RECORD DWGS
AS FABRICATED
6/24/13

00000001.jpg
 TOWN OF WARREN, VT
 COUNTY OF WASHINGTON
 BRIDGE NO.173 REPLACEMENT
 WARREN, VT

ITEM NO.:
 PROJECT NO.: BRF 013-4 (14)
 REFERENCE NO.:
 BRIDGE NO.: 173
 STRUCTURAL FILE NO.:

DESIGN: SAF DRAW: TLB REVIEW: SAF/RLI CHECK: C/JG
 CONSTRUCTION PLANS FRAMING USB JOB# 51622

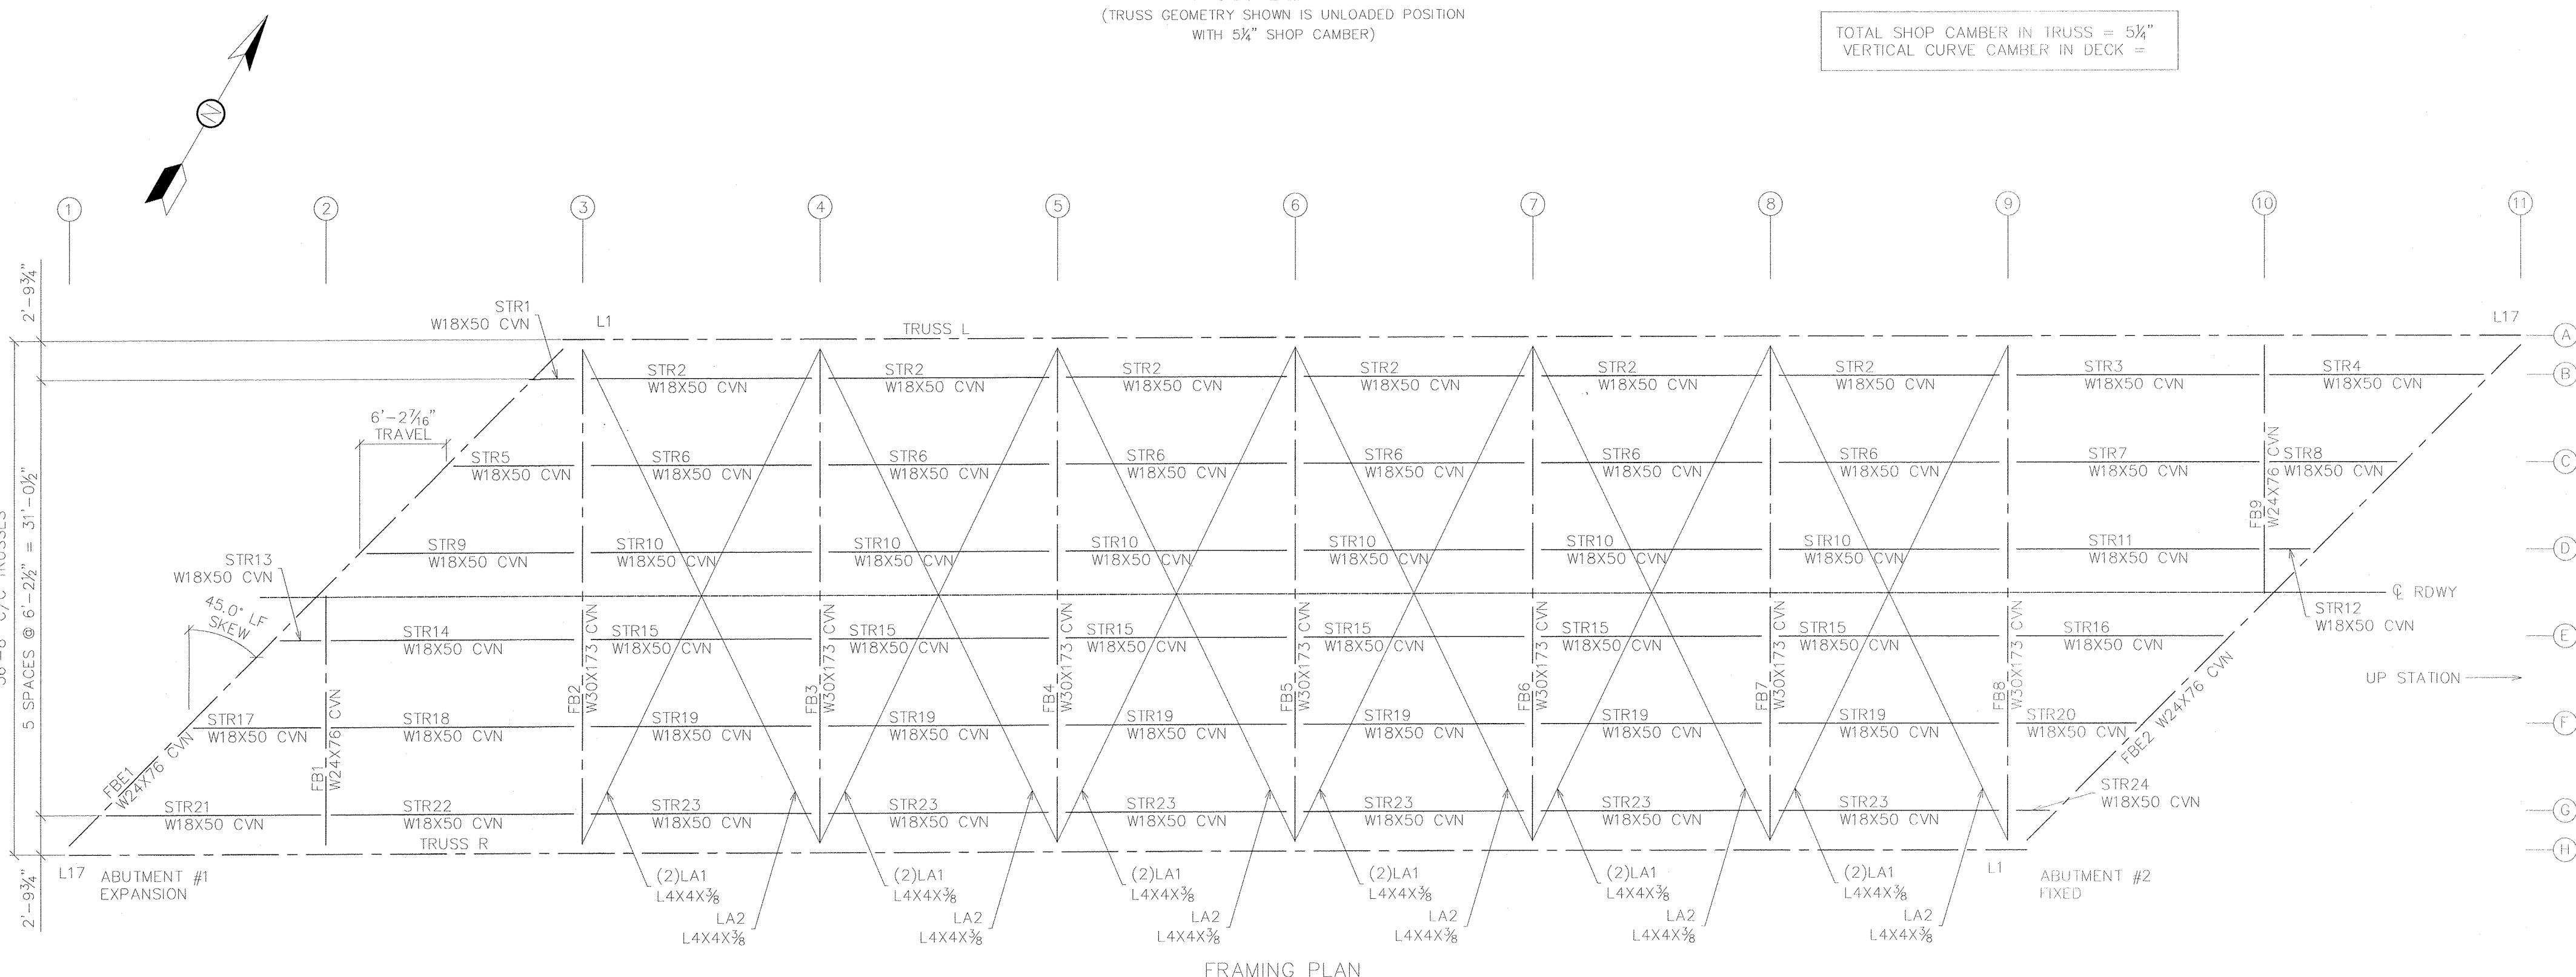
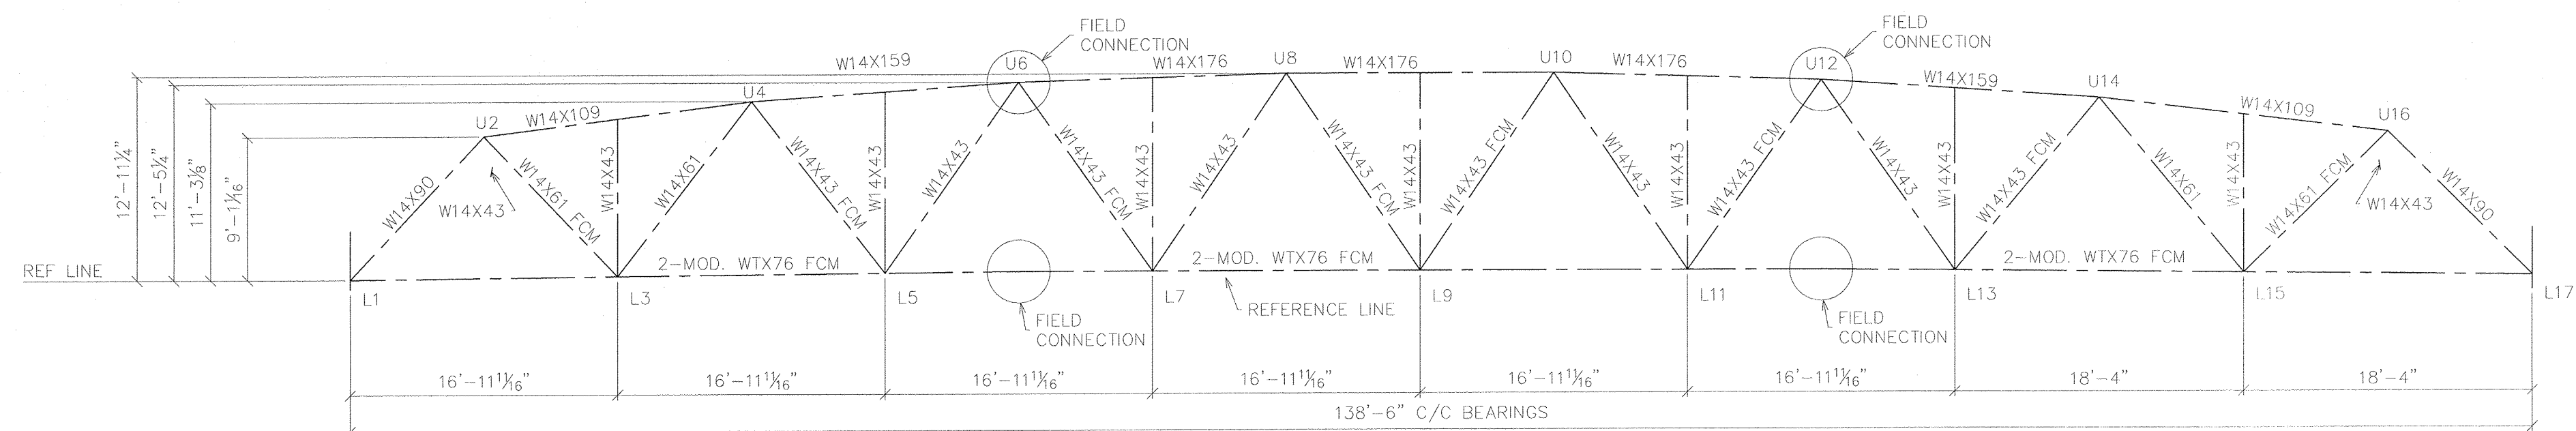
SUBMITTAL LOG	DATE	NO.	DATE	REVISIONS	BY:
INITIAL SUBMITTAL	12/8/12	1	5/15/13	FLOOR BEAM END PLATES WAS 1" THK	TLB
RESUBMITTAL NO. 2	2/5/13	2	5/15/13	ADDED 2" DIA. RAT HOLES IN fb1 & fb9	TLB
CUSTOMER APPROVAL	2/13/13	3	5/15/13	CHANGED WELD WAS 3/8" ALL AROUND	TLB
SHOP REVIEW	-	4	5/15/13	CHANGED BOLT PATTERN	TLB
PRE FAB MTG	-	5	5/15/13	WAS 2" EDGE DISTANCE	TLB
APPROVED FOR FAB	2/28/13	6	6/3/13	DIMENSIONAL ERRORS	TLB
